NL-04-2205

Vogtle Electric Generating Plant
Changes to Technical Specification Bases

Enclosure
Vogtle Electric Generating Plant
Bases Changes

Figure B 2.1.1-1 (page 1 of 1)
REACTOR CORE SAFETY LIMITS VS. BOUNDARY OF PROTECTION

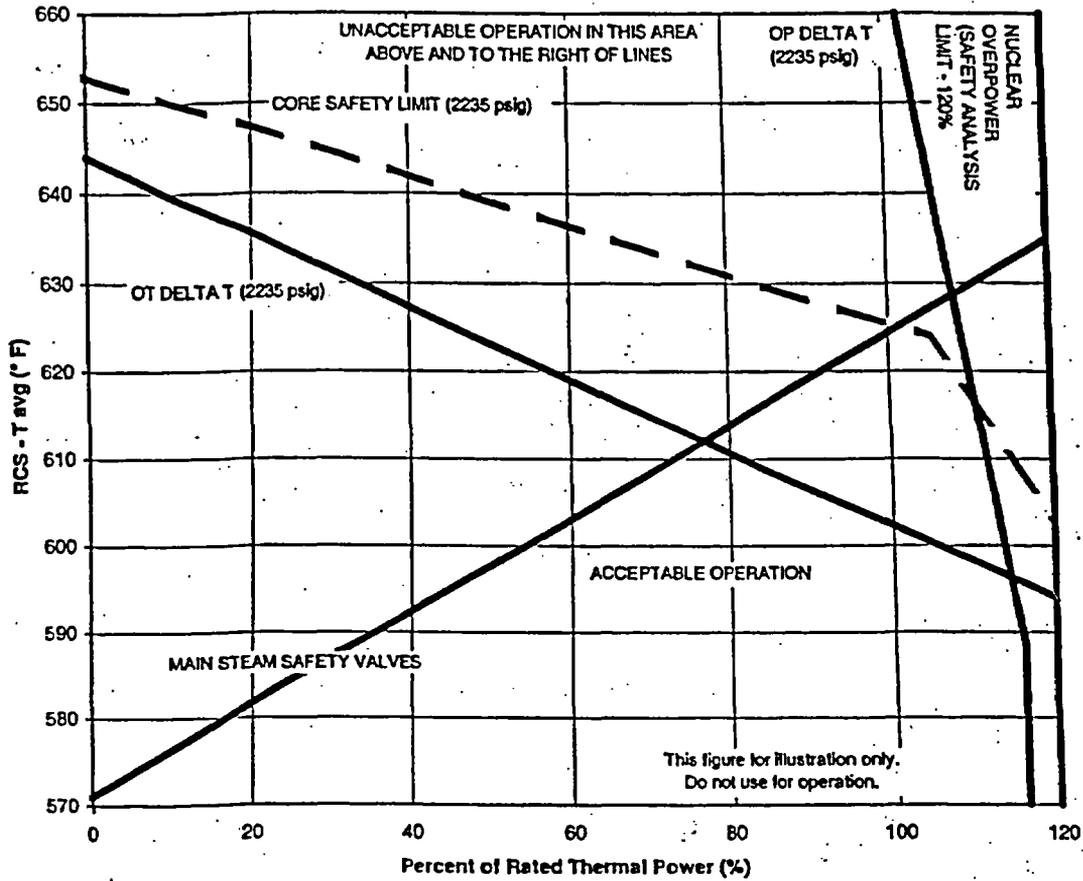
B 2.1.1-7	Rev. 1-6/03
B 3.1.4-5	Rev. 1-8/03
B 3.1.4-10	Rev. 1-8/03
B 3.3.1-1	Rev. 1-9/03
B 3.3.1-19	Rev. 3-6/03
B 3.3.1-21	Rev. 2-6/03
B 3.3.1-22	Rev. 2-6/03
B 3.3.1-31	Rev. 1-9/03
B 3.3.1-55	Rev. 1-4/04
B 3.3.1-56	Rev. 1-4/04
B 3.3.1-57	Rev. 1-4/04
B 3.3.1-58	Rev. 1-4/04
B 3.3.1-58a	Rev. 0-4/04
B 3.3.1-58b	Rev. 0-4/04
B 3.3.1-59	Rev. 1-4/04
B 3.3.1-60	Rev. 2-4/04
B 3.3.1-61	Rev. 2-4/04
B 3.3.1-62	Rev. 3-4/04
B 3.3.1-63	Rev. 4-4/04
B 3.3.1-64	Rev. 3-4/04
B 3.3.1-65	Rev. 6-4/04
B 3.3.1-66	Rev. 2-4/04
B 3.3.1-67	Rev. 0-4/04
B 3.3.2-46	Rev. 1-12/03
B 3.3.3-12	Rev. 1-6/03
B 3.4.13-5	Rev. 1-01/03
B 3.5.1-6	Rev. 1-11/03
B 3.5.1-8	Rev. 2-11/03
B 3.5.1-9	Rev. 2-11/03
